NUMBER: MB 500-32-003, Rev C

ECLIPSE EA500

SUBJECT: ABS Pressure Switch and Harness Reroute

Wire Harness Modification Removal Figure 1 (Sheet 1 of 1)

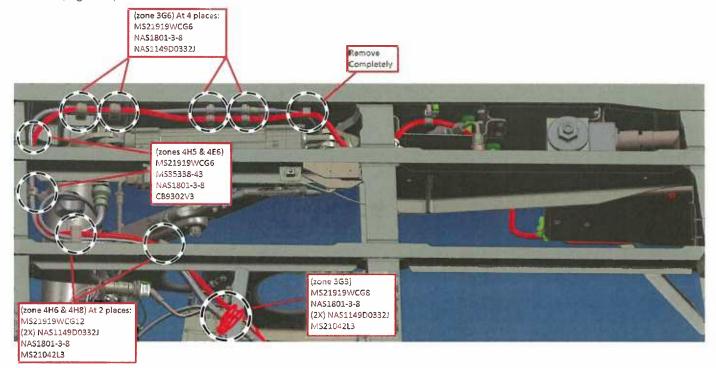
- (1) Make aircraft safe for maintenance. Refer to AMM 20-00-01 MAKE AIRCRAFT SAFE FOR MAINTENANCE.
- (2) Prepare aircraft for modification per 32-123860-1004-WI.
- (3) Remove existing wire harness from the BCM to the WST disconnect branch, shown in red in (Figure 1).

(4) With the ABS wire harness remove, replace the noted provisions to the original hardware stack up (pre-ABS). Refer to 39-108113 and (Figure 1).
